SUBJECT: Discussion and Direction Regarding the Kensington Park Wildfire Risk Assessment

Wildfire Risk Assessment

Kensington Park Structures

Assessment Date: April 27, 2026

Photos (clockwise from upper left): L-shaped planter with mulch and vegetation beneath eaves at front; wooden screens for mechanical equipment on side.

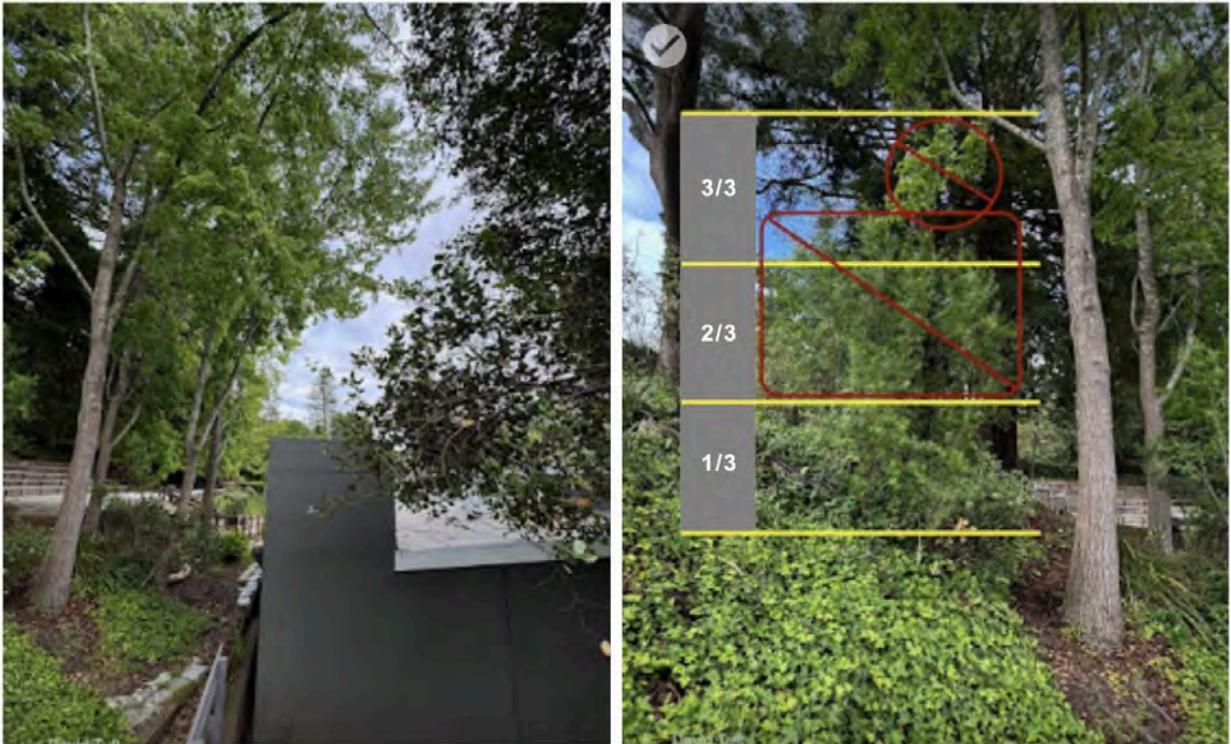
At the Community Center's main entrance and along the west side, an L-shaped planter cutout containing mulch and vegetation sits directly beneath the front overhang and eaves — a condition that will not meet the draft code. Rounding the south corner, additional landscape cutouts contain small trees, and two wood-slatted screens concealing mechanical equipment, which are located under the eaves, also noncompliant.

On the east side (rear) of the building, approximately 18 inches from the building perimeter, a water management system traps combustible organic debris beneath a drainpipe. Behind it sits a pressure-treated wood retaining wall, positioned directly behind a concrete retaining wall. The wooden wall shows signs of age — deteriorating posts, and the presence of sandbags and straw wattles suggests it no longer effectively manages hydrostatic pressure. The combination of trapped debris and a wooden retaining wall close to the building creates a meaningful ignition hazard. A combustible wooden barrier at the end of the east wall presents a further risk.

The new draft regulations have also reduced the allowable overhang of tree limbs over a roof from 10 feet to 5 feet. The District appears to have maintained good limbing practice on the north and northeast sides of the building in the past. However, new growth now appears to be within 5 feet of the abandoned chimney, and tree branches overhang the parapet section of the roof at the northeast corner. Fire risk in this area is compounded by understory bushes that grow from the ground to the lower branches of these overhanging trees — a classic ladder fuel configuration that can allow a ground fire to climb rapidly into the tree canopy and then to the roof.

- Remove all mulch and combustible vegetation from beneath the eaves at the entrance, west-facing, and south-facing sides of the building. A landscape architect can suggest attractive noncombustible alternatives — decorative stone, tiles, pavers, sculpture — that maintain the building's welcoming character while meeting fire safety standards.

- Replace the wood-slatted screens concealing the mechanical equipment on the south side with metal or other noncombustible alternatives, such as fiber-cement panels, that can be painted to match the building.

- Implement a routine debris management plan for the rear of the building, with particular attention to the area beneath and around the water management system where organic material accumulates.

- Given the apparent age and declining effectiveness of the wooden retaining wall, consider replacing the entire rear drainage and retaining configuration with a more comprehensive system designed to manage both hydrostatic pressure and

- Replace the combustible wooden barrier at the end of the east wall with a noncombustible alternative, such as metal or fiber cement board.
- Limb all trees with branches within 10 feet of the roofline. While the draft regulations specify 5 feet, the 10-foot standard provides greater protection at minimal additional effort and is recommended. At the northeast corner, prune trees completely away from the roofline. Remove the understory bushes below the overhanging trees, or prune them to no more than one-third the height of the lowest tree limb, to eliminate the ladder fuel hazard.

Photos (from left): vents needing repair, and rodent mesh screen; gable vents requiring check for screen size; and gaps found around several wall penetrations.

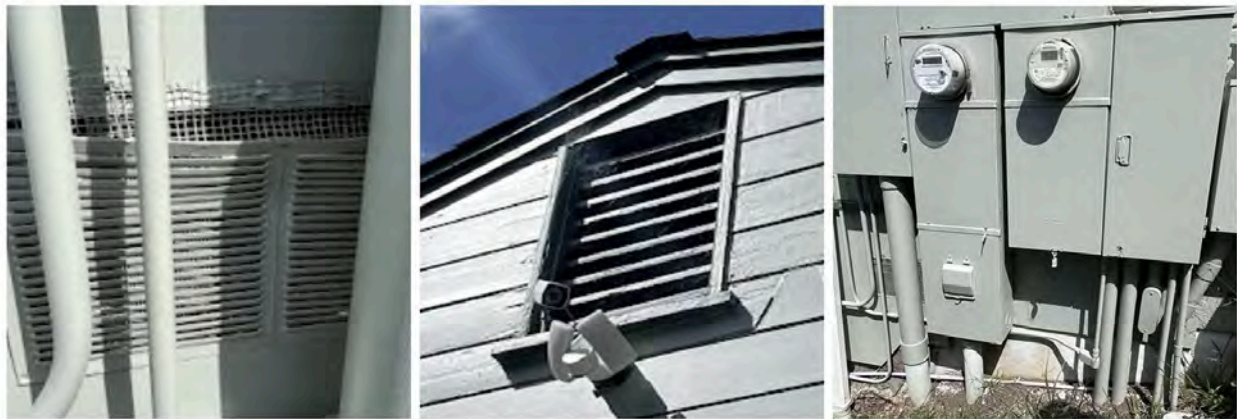
The Recreation Building's foundation and gable vents do not appear to have appropriately-sized ember-resistant mesh screening. Gaps and openings around electrical and other utility boxes attached to the south wall also present points of entry for embers.

- Retrofit all foundation and gable vents with 1/16-inch or 1/8-inch corrosion-resistant mesh screening. This is a high-priority, relatively low-cost action.
- Inspect all utility boxes and conduit penetrations on the south wall. Cover or enclose any gaps and openings with appropriate mesh or intumescent caulk to prevent ember accumulation and intrusion.

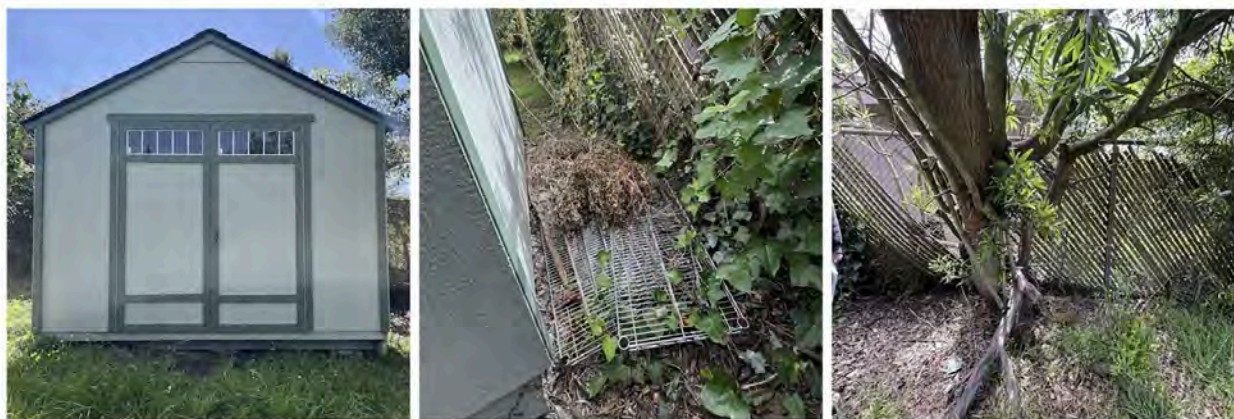
Ongoing vegetation management in Zone 2 on the south and west slopes is necessary to prevent the buildup of fuel that could drive fire toward the building and park. Invasive

- Maintain the hillside vegetation in Zone 2 to the south and west in accordance with the spacing and clearance standards described in the Appendix. Update the park's vegetation management schedule to include this area and address rapid regrowth and invasive species.
- Keep grasses and forbs cut down to a maximum height of 4 inches
